EAST TOWN CROSSING FRONTAGE IMPROVEMENTS

COVER SHEET

EAST TOWN CROSSING SHAW ROAD IMPROVEMENTS

PROJECT: **EAST TOWN CROSSING**
MULTIFAMILY DEVELOPMENT
PIONEER WAY & SHAW RD. PUYALLUP, WA

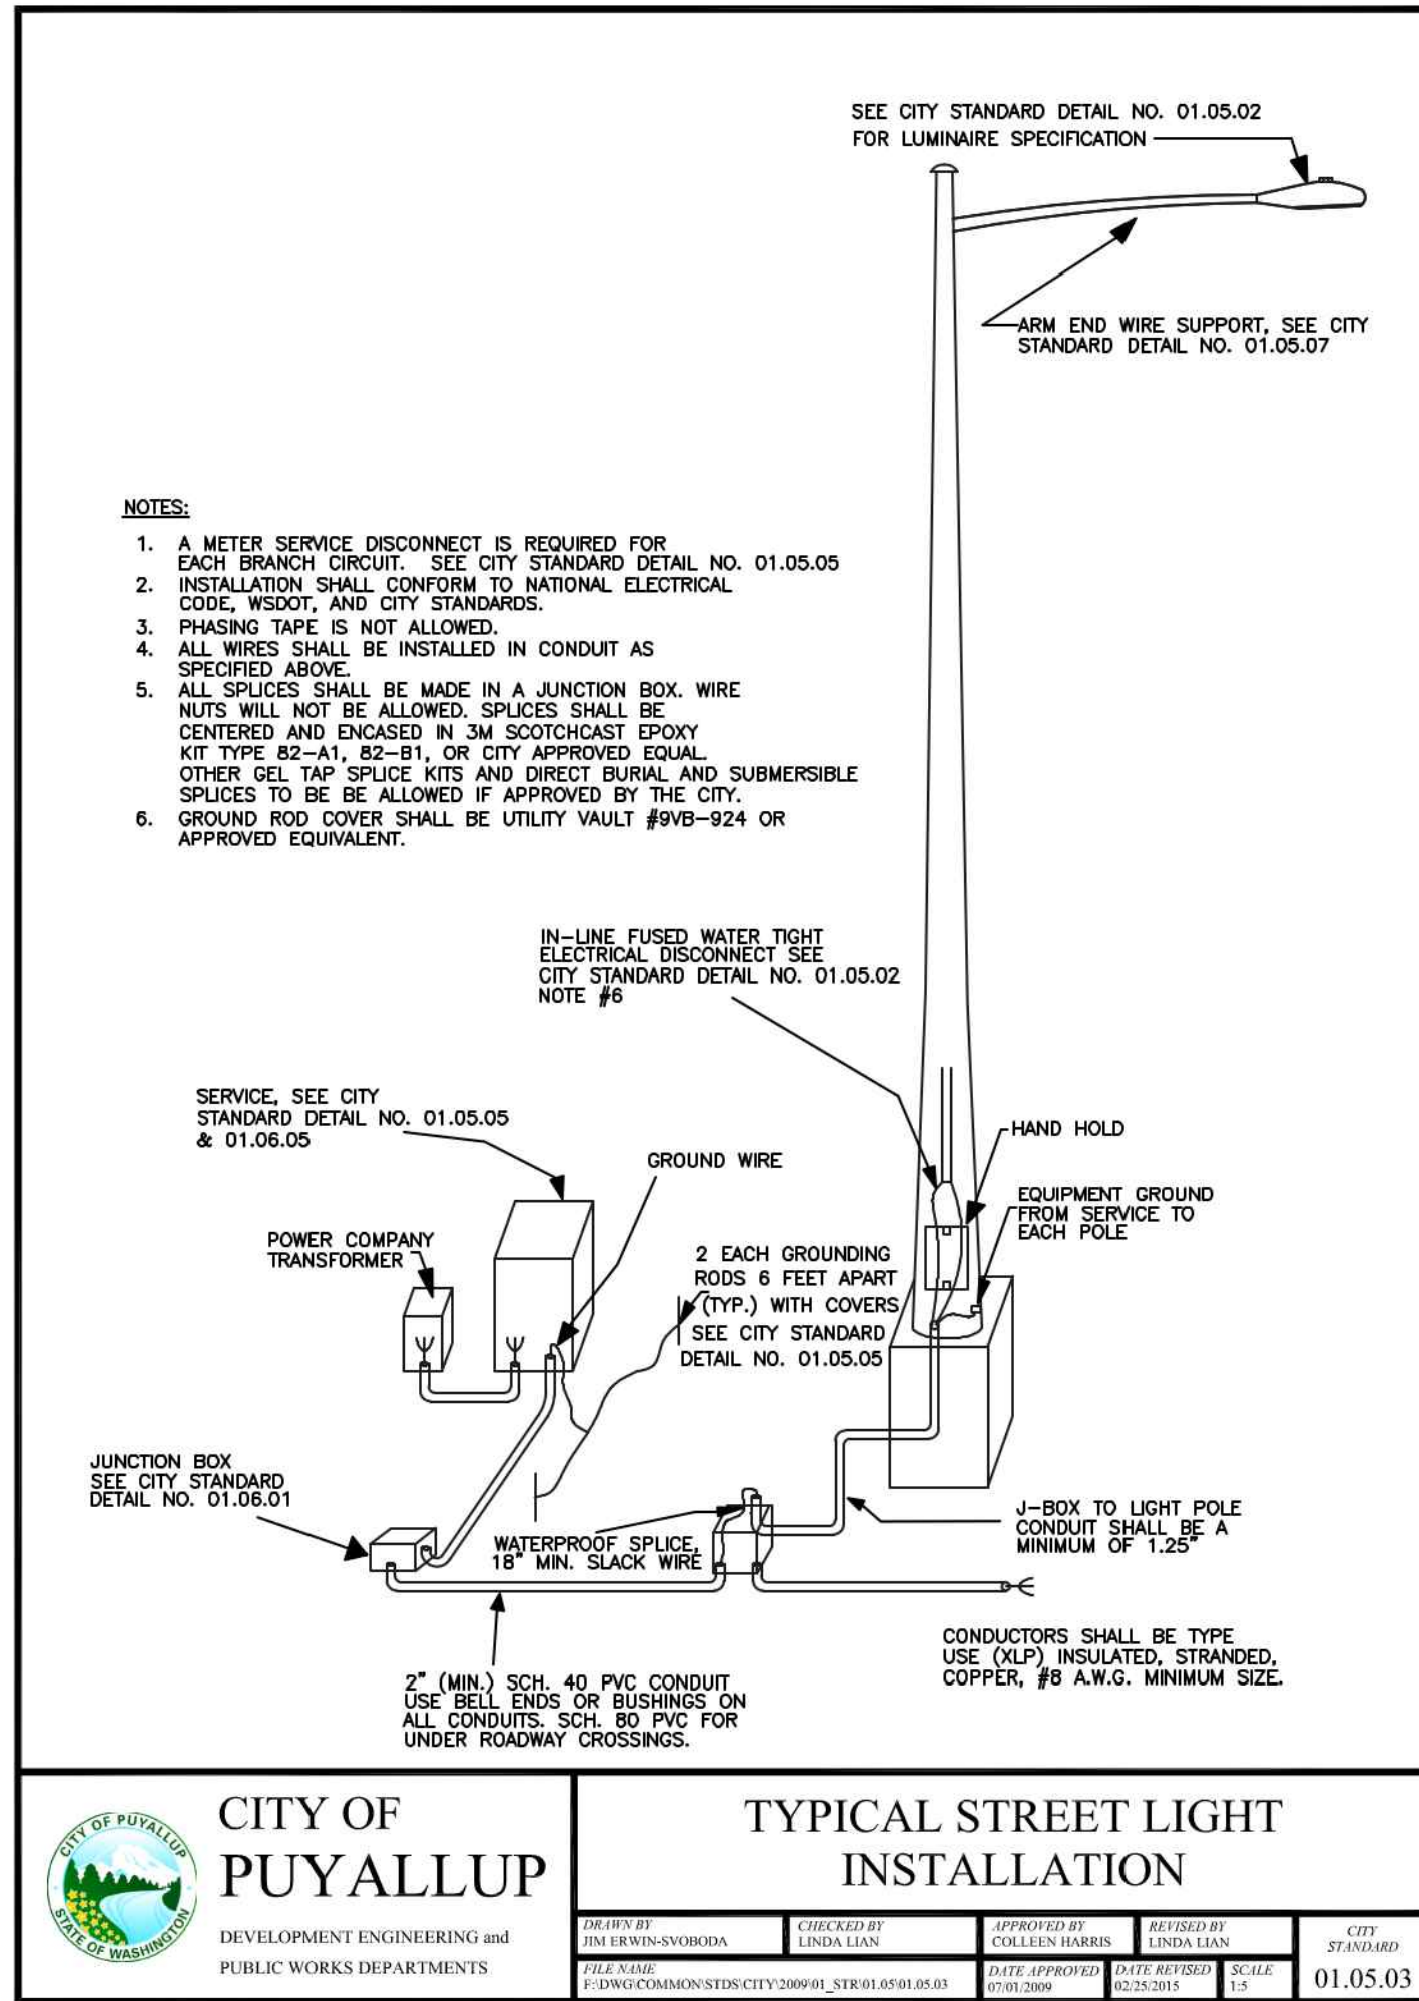
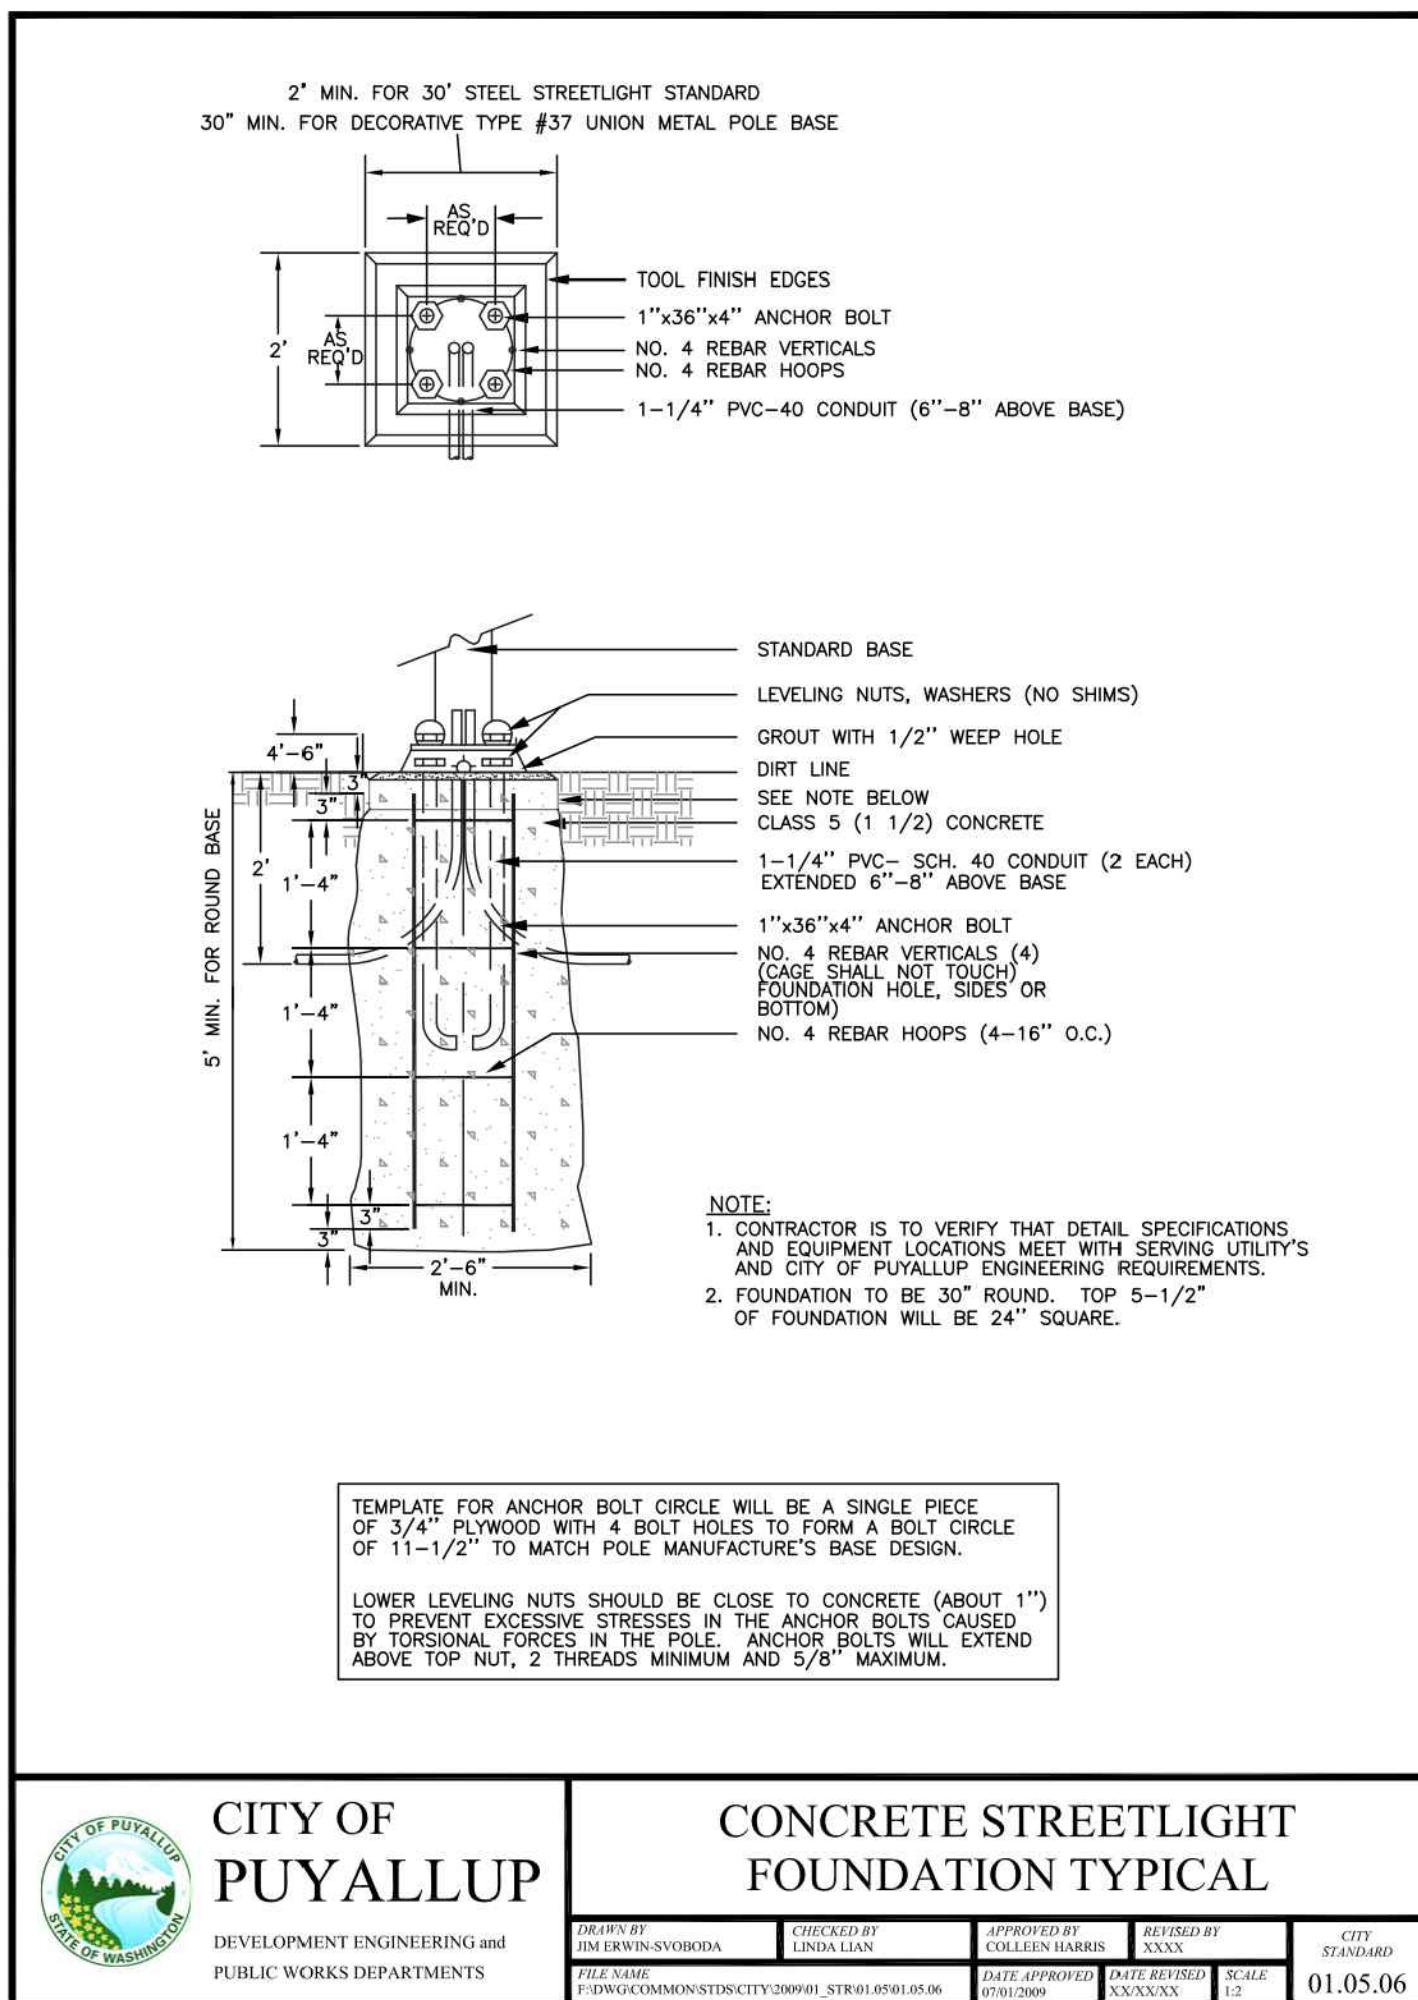
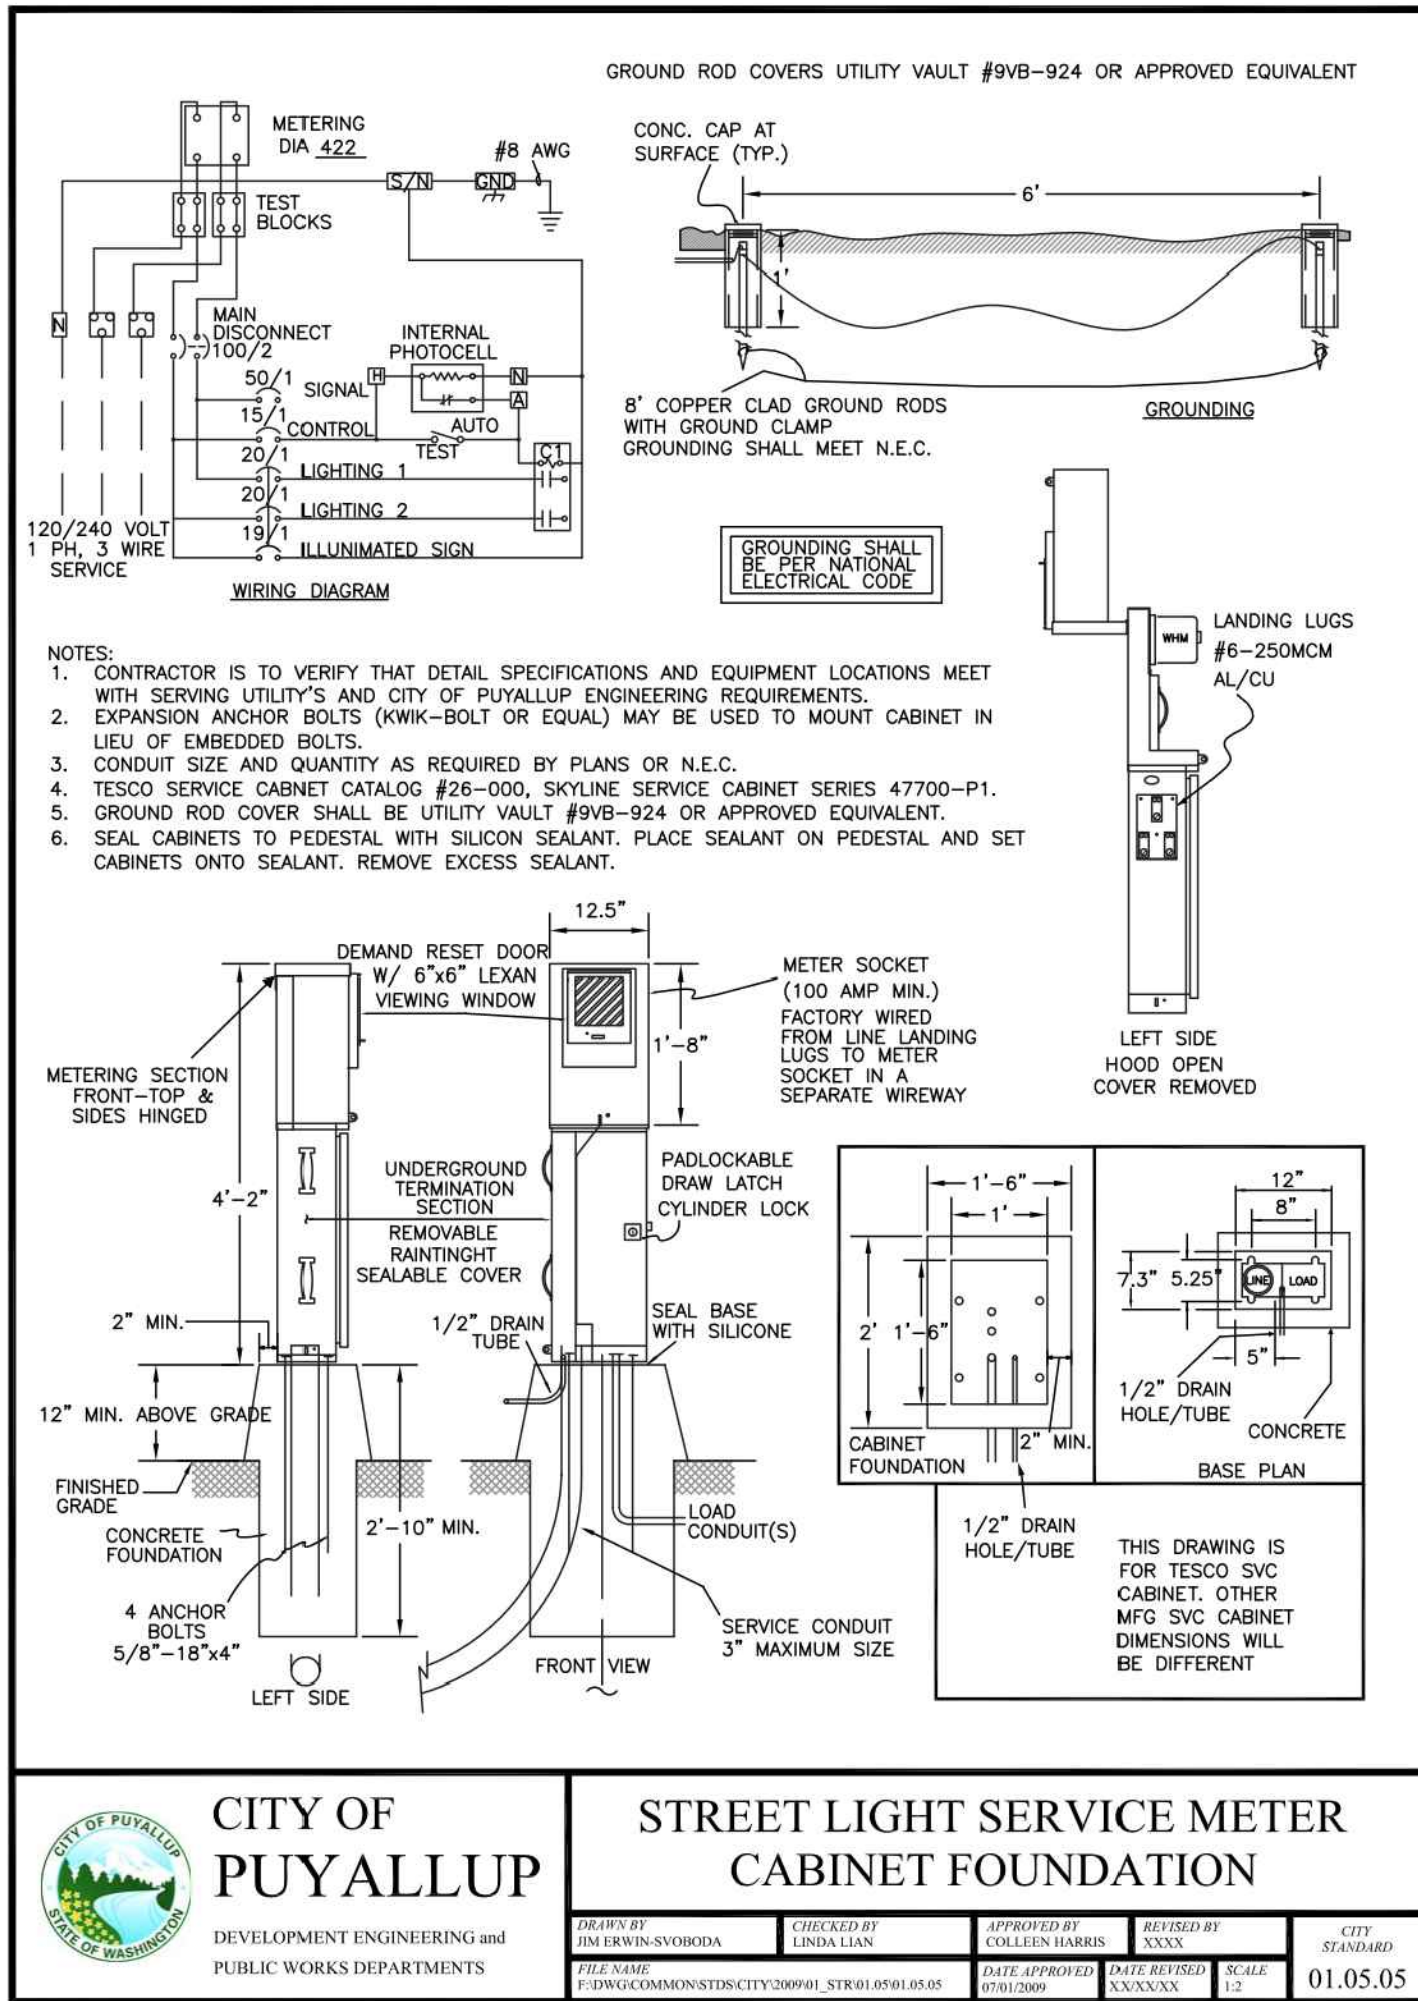
Lighting engineer to verify proposed design will meet or exceed WSDOT light level requirements for pedestrian facilities. Average (fc): 0.8 Uniformity: 4:1 Civil Plans - SL.1

Add the following to Note 6:
*6a. A copy of the load calculations shall be provided to the City's signal technician prior to installation.
*6b. Contractor shall contact the City's signal technician when the lights are ready to be energized.
[Plans; Sht SL.1 of 21]

show where J-box location will be, armorcast J-boxes should be used. SL.1 SH

show actual location of new underground conduit, in right-of-way SL.1 SH

Frontage design not consistent with other sheets in this submittal. Civil Plans - SL.1

If underground conduit at new approach, confirm Sch. 80 PVC conduit or replace if necessary. [Plans; Sht SL.1 of 21]

J-box and (2) runs of conduit to extend to southern edge of frontage Civil Plans - SL.1

Photometric analysis needs to account for existing City standard lighting on both sides of the street (including lighting at signalized intersection). Assume utility/PSE mounted streetlights will be removed with project. Civil Plans - SL.1

City standard streetlights are required every 150ft (minimum). Project to provide GE EVOLVE ELR2 Fixtures ERL2-3-23-A3-40-D-Gray-A-V1 (City to provide latest part numbers) How will lights be powered? New service cabinet? Using the existing signal service cabinet? Streetlights shall have shorting caps installed with remote photocell located on the service cabinet. Civil Plans - SL.1

show what streetlights are existing and what are new. previous page states remove and relocate streetlight/power pole, which ones will be moved, verify conduit continuity and ability to maintain and pull wire if needed, add extra 2" spare conduit throughout width of project, our standard states schedule 80 conduit under roads/driveway...has this been verified it exist, if not replace with schedule 80 across entrance & verify and state existing wire size and it meets current standards.... SL.1 SH

It is the sole responsibility of the design engineer to ensure streetlight design/placement is outside of the 10ft minimum "safe zone" area. The City will not allow streetlights to be within 10ft of the PSE primary for safety reasons. Place this note on this sheet Civil Plans - SL.1

Streetlight design shall provide the following:
1. Provide details on how streetlights will be powered
2. Location of conduit runs
3. Wiring Schedule
a. Conduit size and type for each raceway
b. Conductors details
4. Pole schedule
a. STA & offset for each luminaire
5. Show location of junction boxes
Civil Plans - SL.1

is this the same one on sheet 7 that says relocate, if it going to be removed why does the sidewalk curve around it SL.1 SH

At proposed City light standard locations, encapsulate the light base into the sidewalk and/or shared use path pour. [Plans; Sht SL.1 of 21]

Clearly identify as being removed. Existing PSE utility pole mounted streetlights do not meet current City standards and will be removed with installation of City standard streetlights. Civil Plans - SL.1

Clearly identify as being removed. Existing PSE utility pole mounted streetlights do not meet current City standards and will be removed with installation of City standard streetlights. Civil Plans - SL.1
